Docket No. 50-325

By letter dated July 1, 1980, we transmitted Amendment No. 29 to Facility Operating License No. DPR-71 for the Brunswick Steam Electric Plant Unit No. 1. Page 3/4 2-7 of the Technical Specifications attached to Amendment No. 29 referenced "Fuel Type P8DRB285." The reference should have been "Fuel Type P8DRB265H. Please substitute the enclosed page 3/4 2-7 for the existing incorrect page.

SUPPORTING AMENDMENT NO. 29 TO FACILITY LICENSE NO. DPR-71

BRUNSWICK STEAM ELECTRIC PLANT, UNIT NO. 1

FIGURE 3.2.1-6

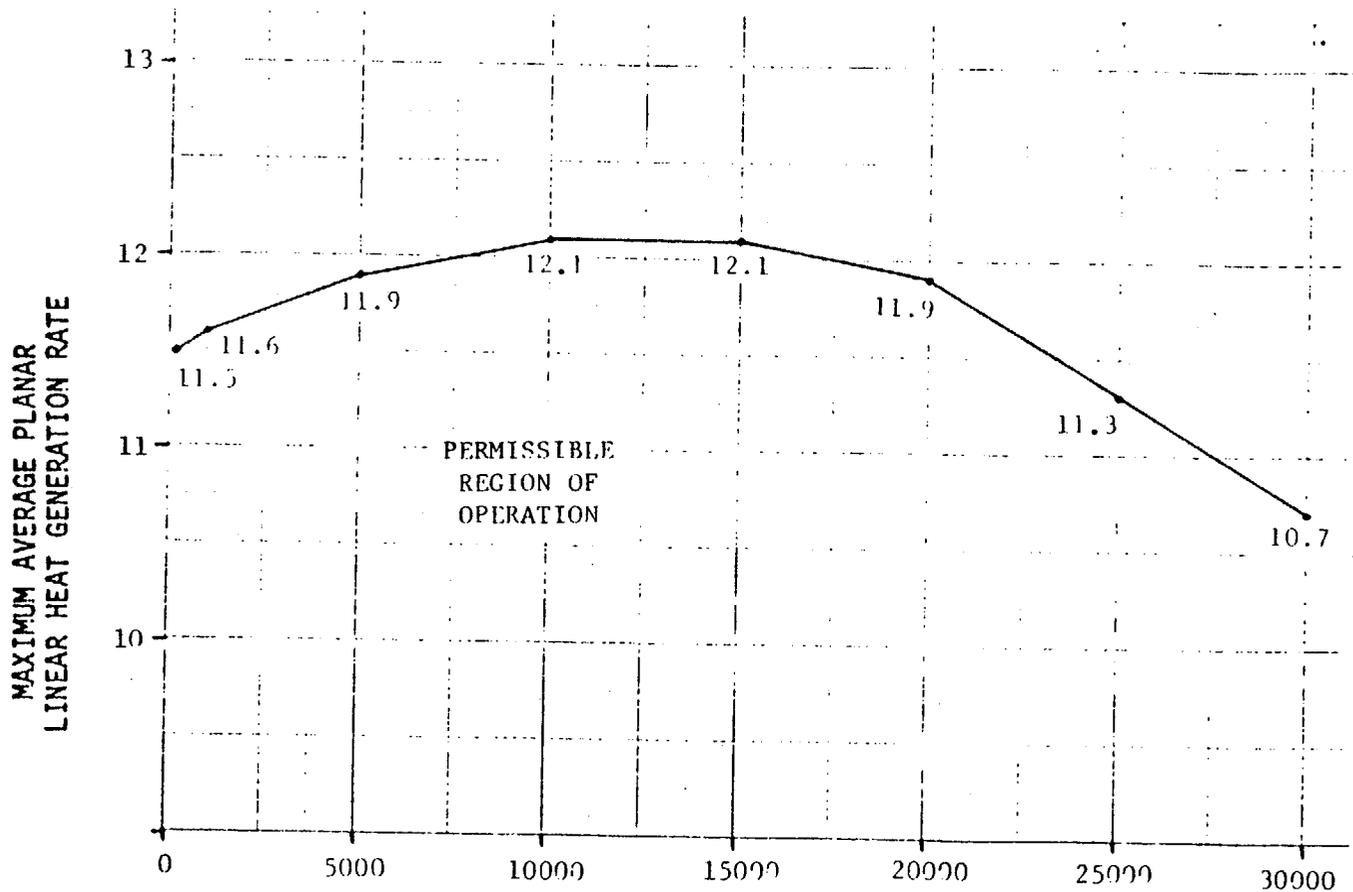
By letter dated July 1, 1980, we transmitted Amendment No. 29 to Facility Operating License No. DPR-71 for the Brunswick Steam Electric Plant Unit No. 1. Page 3/4 2-7 of the Technical Specifications attached to Amendment No. 29 referenced "Fuel Type P8DRB285." The reference should have been "Fuel Type P8DRB265H."

PLANAR AVERAGE EXPOSURE (Mwd/t)  
FUEL TYPE P8DRB265H (P8X8R)  
MAXIMUM AVERAGE PLANAR LINEAR HEAT  
GENERATION RATE (MAPLHGR)  
VERSUS AVERAGE PLANAR EXPOSURE
